**FORMAL REPRESENTATION: OBJECTION TO PLANNING APPLICATION
2026/91923**

Land at St Luke's, Bierley Marsh, East Bierley, BD4 6PL

Objection – failure to comply with the Kirklees Highways Design Guide SPD (2019), the Kirklees Housebuilders Design Guide SPD (2021) and current national highway design guidance

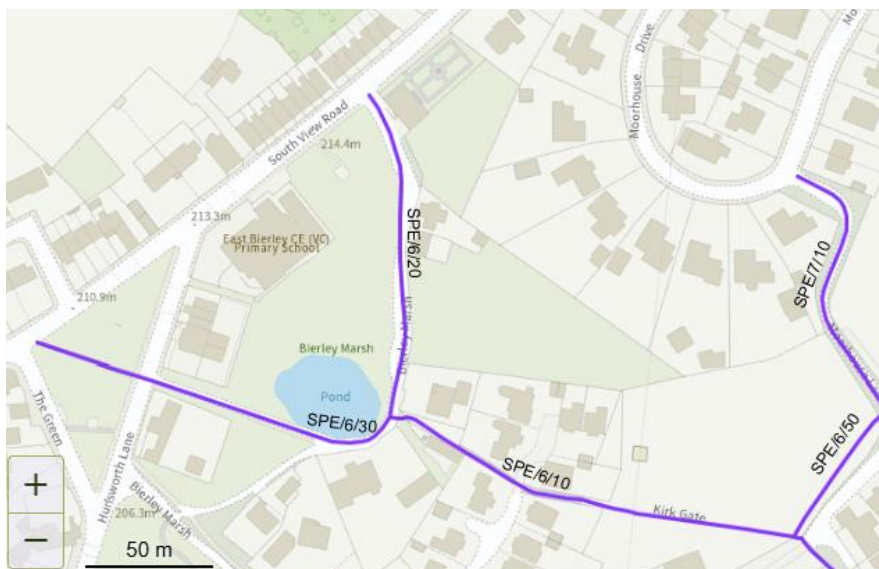
Bierley Marsh is an unadopted road which carries a legally recorded public footpath (Spenborough Footpath No. 6).

Under S34(1) of the Road Traffic Act 1988, it is an offence to drive a mechanically propelled vehicle, without lawful authority, on a road that is a footpath. However, it is not an offence if a person drives a mechanically propelled vehicle on any land within fifteen yards of a road for the purpose only of parking the vehicle on that land.

It is also worth considering the phrase "lawful authority". Clearly, there may be instances when drivers have lawful authority to drive on a road which carries a footpath. For example, local landowners such as yourself have to drive along Bierley Marsh to access your property. However, the law places the onus on everyone driving on a road which carries a footpath to prove that they have the right to do so. Simply having done so for a number of years may not necessarily constitute proof of a legal private vehicular right.
